DEPARTMENT OF VETERANS AFFAIRS
Veterans Health Administration
National Health Physics Program
2200 Fort Roots Drive
North Little Rock, AR 72114

Re: VHA Permit Number 14-00822-01, Request for Decommissioning for Unrestricted Release of Buildings 3 & 28 for Demolition

Request for Additional Information (RAI)

Note: This RAI involves review of decommissioning document submitted October 6, 2008 (received by NHPP October 16, 2008) in support of a request to release Bldgs. 3 and 28 for unrestricted use: *Radiological Assessment of the Department of Veterans Affairs Medical Center: Deconstruct Buildings 3 and 28, Iowa City, IA (Prepared August 26, 2008, 4 Volumes)*

③ Item 9.b.

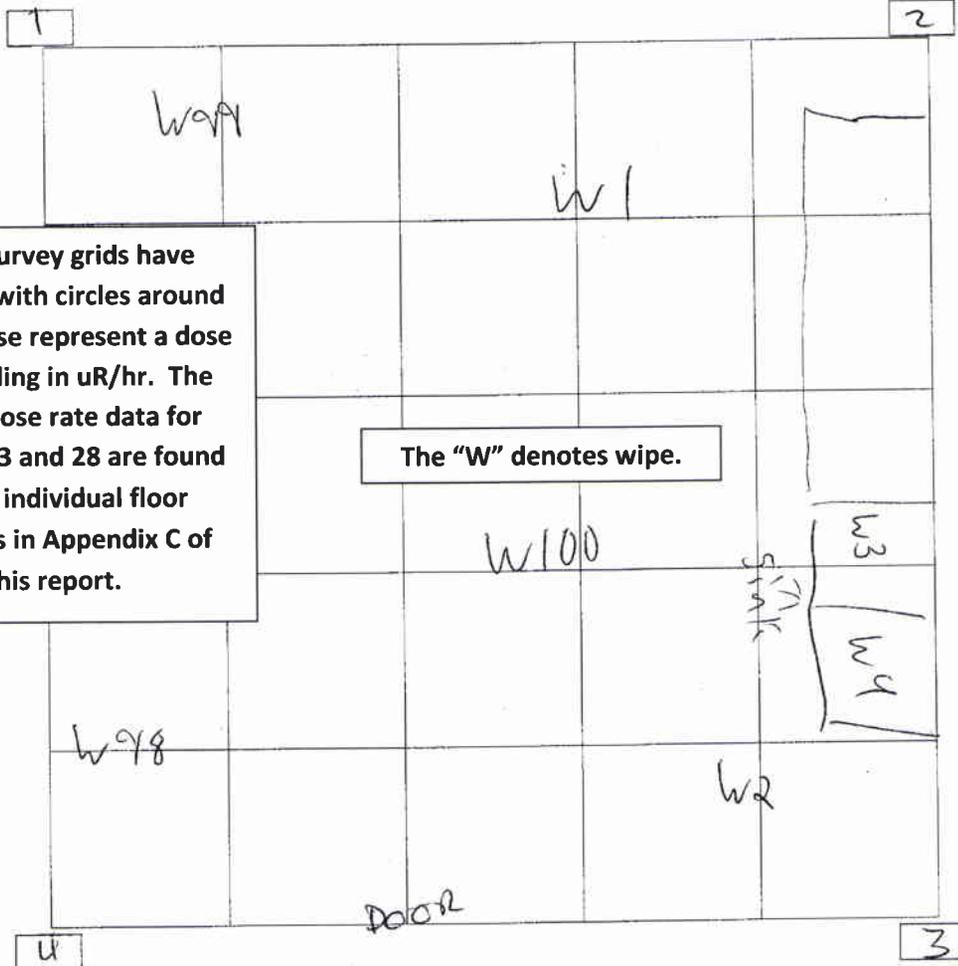
3. The excerpt below is from item 9.b. and notes that an annotated diagram(s) for Bldg. 3 and 28 would be provided. Please provide annotated diagram(s).

HRG Response: The circled numbers represent exposure rates measured in uR/hr using an Invision 451P pressurized ion chamber. We will provide an annotated diagram for Building 3 and 28 to serve as keys.

The "6" is the order this survey group was

Item 19

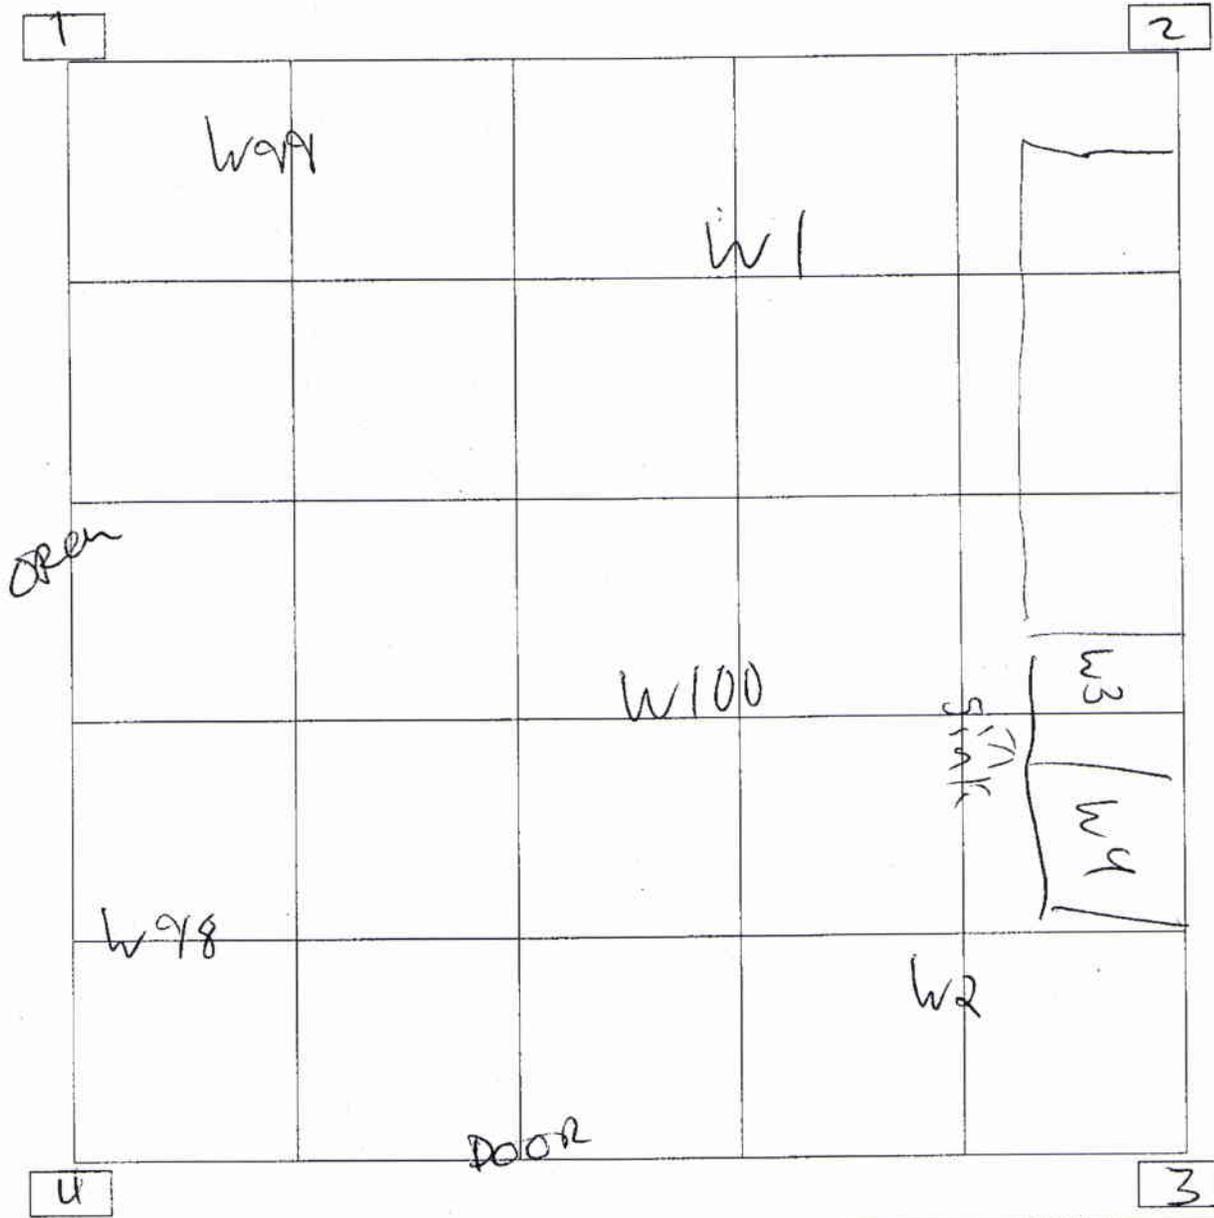
4. The excerpt below is from item 19.a. Please provide corrected page.

19. In Appendix O (Bldg. 3, Floor 2, Section D):
- a. The wipe count data for grid 3-2-218-1 is incomplete. It appears to be missing header information due to landscape mode page orientation. Please provide comment or submit a corrected page.

HRG Response Page format will be corrected

Grid: <u>3-2-218-1</u>	Inst.: Ludlum 3 w/44-9	Inst.: Ludlum 3 w/44-9
Date: <u>8-11-07</u>	Ser. No.:	Ser. No.:
Time:	Cal. Date:	Cal. Date:
Surveyor:	Src. Chk.:	Src. Chk.:
Signature:	Inst.: Invision 451P	Inst.:
Signature:	Ser. No.:	Ser. No.:
Notes:	Cal. Date:	Cal. Date:
	Src. Chk.:	Src. Chk.:
